TECHNICAL INSTRUCTION

TITLE		T.I. No. 101/T59 Issue 1	
Kestrel Rudder Actuator Inspection			
CLASSIFICATION		CAA MANDATORY	
COMPLIANCE		A single inspection to be completed by 1st March 1982	
OBJECTIVE		To ensure structural integrity of the rudder actuator, part number T59A-45-427	
JUSTIFICATION		Cracks on the fitting have occurred, in Area 'A' shown on diagram, the cause of which cannot be established.	
APPLICABILITY			
All Slingsby T59A, B, C, D, E, F, G, H & J gliders including spares held in stores and all rudder assemblies pre and post Mod 25.			
CONSEQUENTIAL LIMITATIONS			
If cracking is found the part must be discarded immediately and scrapped.			
ACTION			
<p>Remove the rudder in accordance with Addendum A.2.2 of the Pilots Notes. Visually examine (using a x5 magnification) the actuator for cracks especially in the area of the central weld 'A' see diagram. Should any sign of cracking be found then the existing part must be discarded and scrapped.</p> <p>Replace Rudder.</p> <p>Anotate aircraft log book showing compliance of this T.I.</p> <p>All findings to be reported to the undersigned.</p>		<p>Inspect these areas closely</p>  <p>T59A-45-427</p>

T.I. No. 101/T59 Iss 2

T5

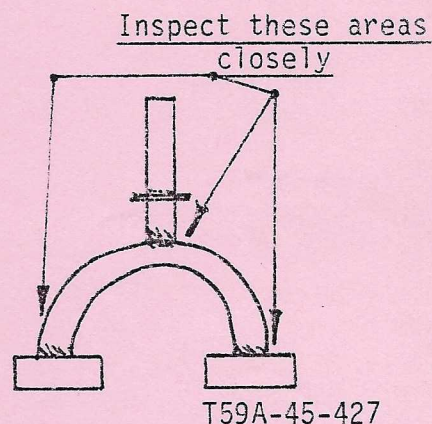
JUSTIFICATION Further examples of cracking in Area A have been found on German built gliders.

ACTION Remove the rudder in accordance with Addendum A.2.2. of the Pilots Notes. Visually examine (using a x5 magnification) the actuator for cracks especially in the area of the central weld 'A' see diagram. Should any sign of cracking be found then the existing part must be discarded and scrapped. Replace Rudder. Annotate aircraft log book showing compliance of this T.I.

If cracking is found the part must be discarded immediately and scrapped.

If inspection reveals a defective actuator, a replacement T59A-45-427 Issue 5 (one off) actuator may be obtained from SA PLC.
